***Project: 1216 E. Venice Ave. Sign Modification***  
**Site and Development Plan Amendment Petition No. 17-08SP**

**Staff Report**

Map 1: Aerial Photograph

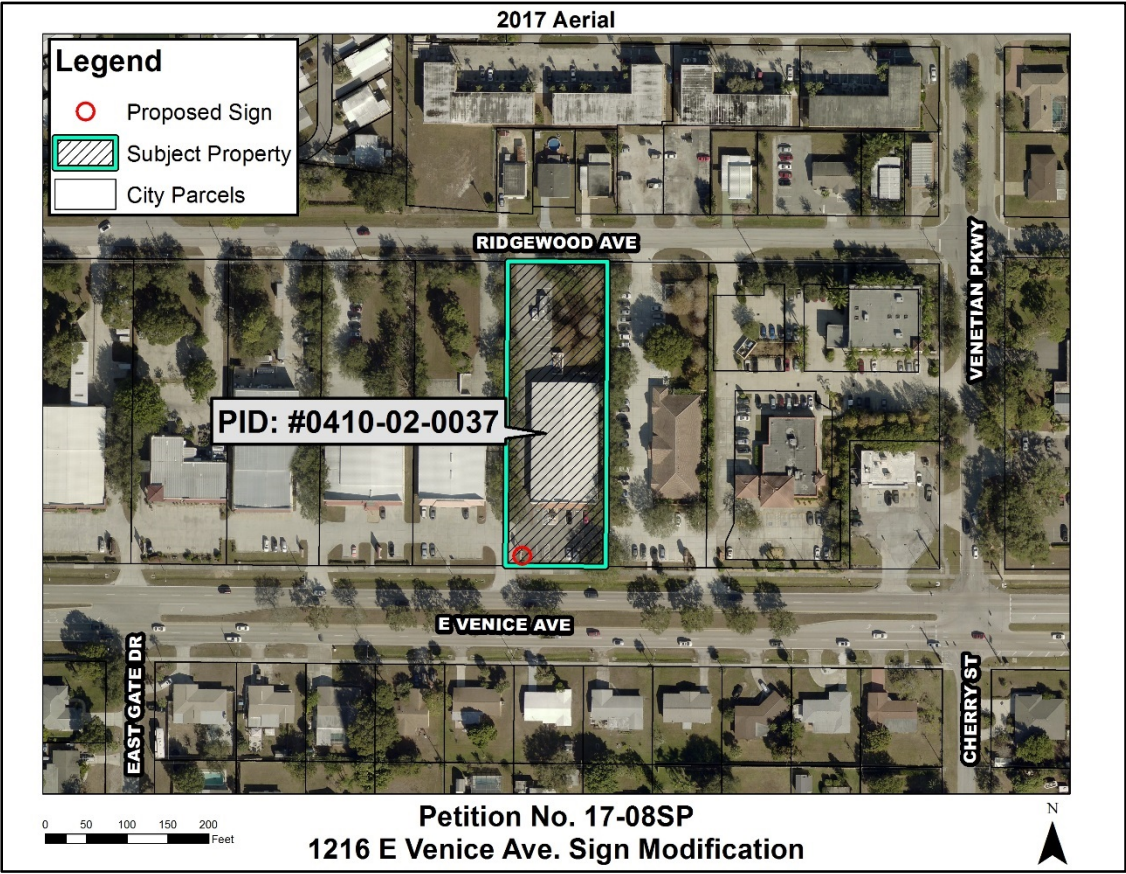
Existing 20-foot tall pylon sign.

The yellow outlined area is where existing pavement is proposed to be removed to comply with the minimum five-foot setback from edge of pavement.
